# **SUPPLEMENTAL PACKET**

**From:** Ron Moore  
**Sent:** Tuesday, October 18, 2016 8:49 AM  
**To:** 'Tim Freeman'  
**Cc:** 'Candace Amberg'  
**Subject:** FW: Brockman Trucking

Amber,  
Please let me know the result of your final review of the revised-revised Brockman trucking landscape plan.  
Thanks,  
Ron

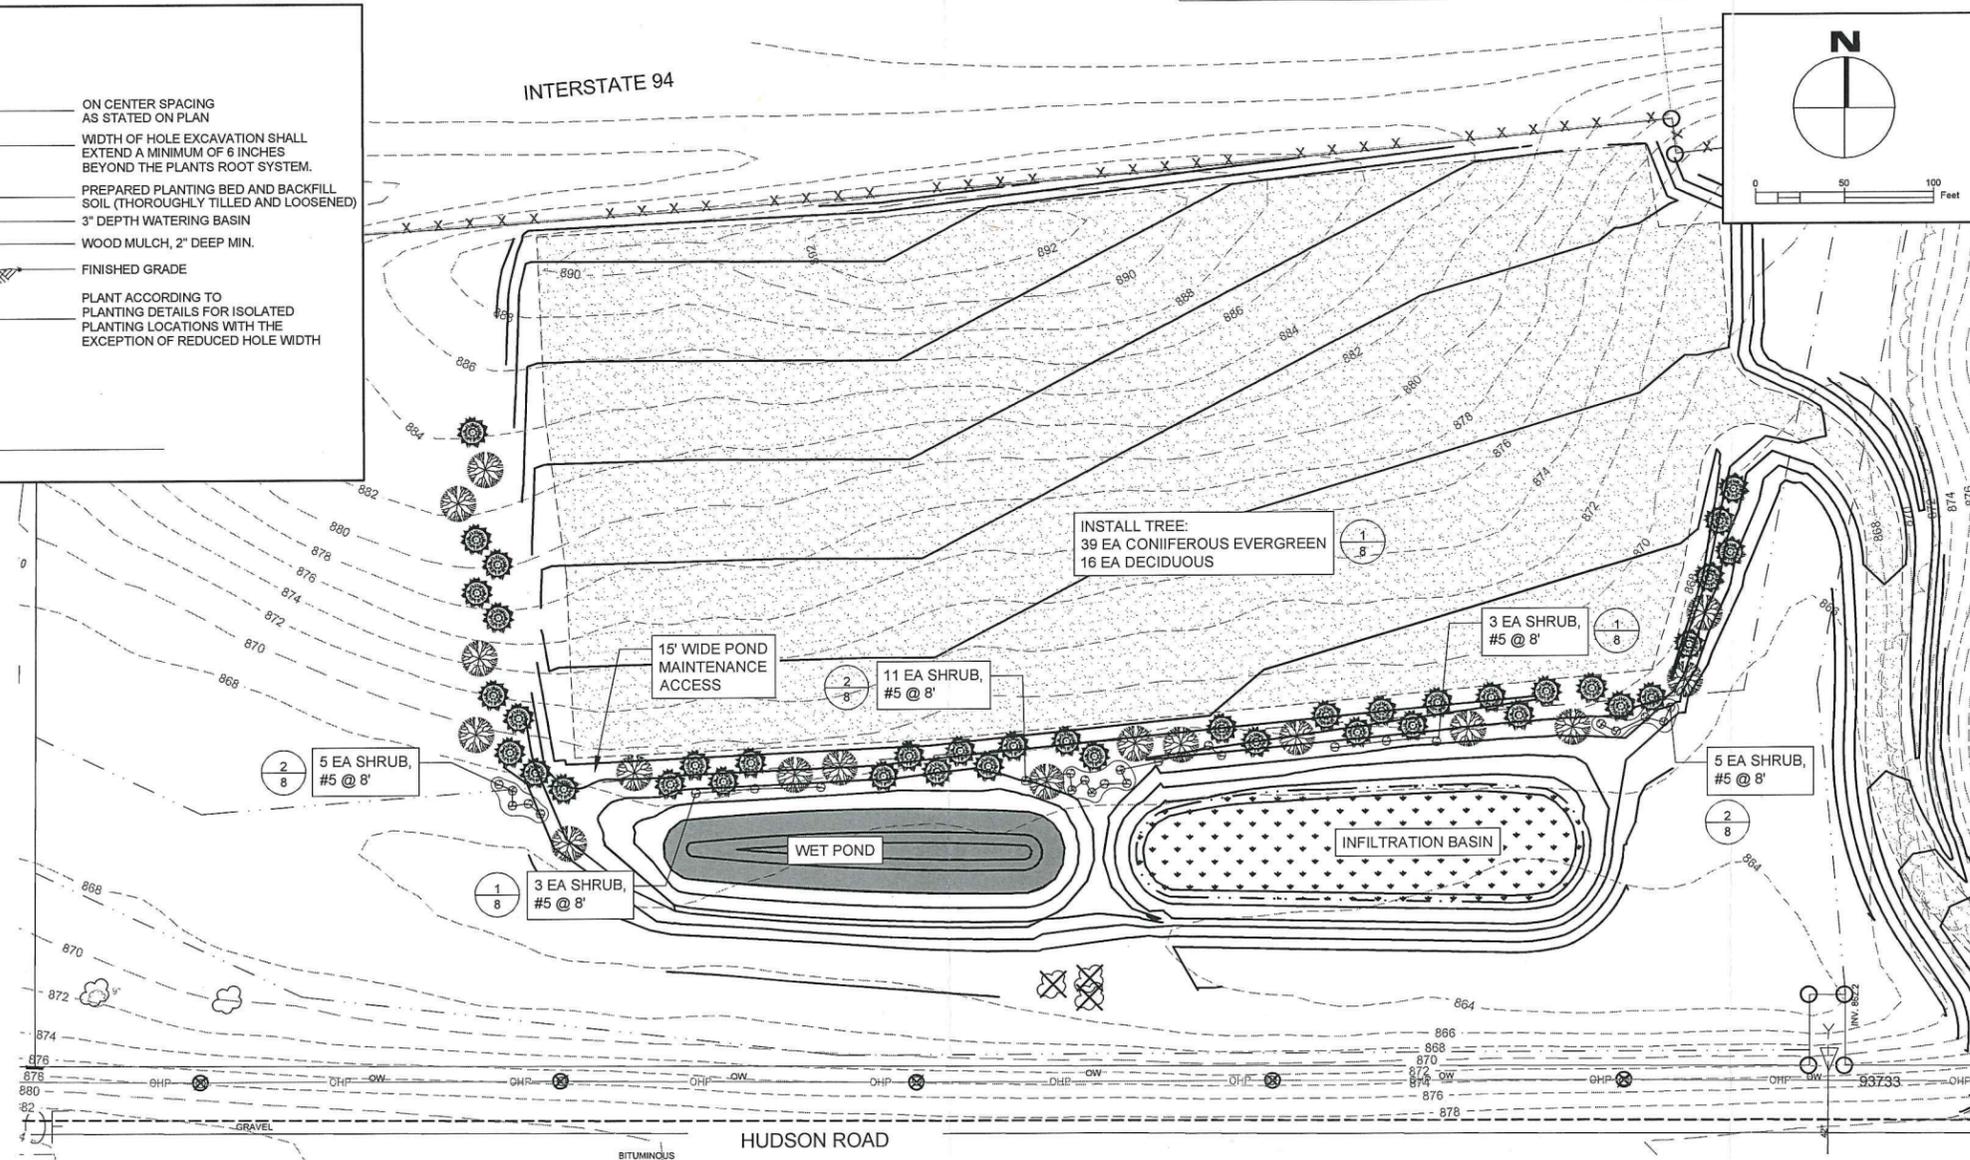
Tim,  
I am forwarding an email string with Candace Amberg regarding the landscape plan. Based on her comments, the landscape plan needs to reflect the evergreen trees being spaced 12-15 feet on-center and the deciduous trees need to be spaced 20-25 feet on-center. Where the deciduous trees are located, evergreens need to be staggered behind them to avoid gaps in the screening. The landscape plan will need to be revised to reflect these comments.  
Thanks,  
Ron

Typically around 12'-15' for evergreens and deciduous I would space more around 20'-25'. That's where staggering evergreens behind the deciduous comes in handy and filling in gaps with shrubs.

Yes I did, I think for the most part it looks acceptable, as long as spacing is tight enough to keep the trees a little closer together with the staggering since it's hard to tell what the spacing is. Again, just be sure to mix up the species and no Colorado Spruce.
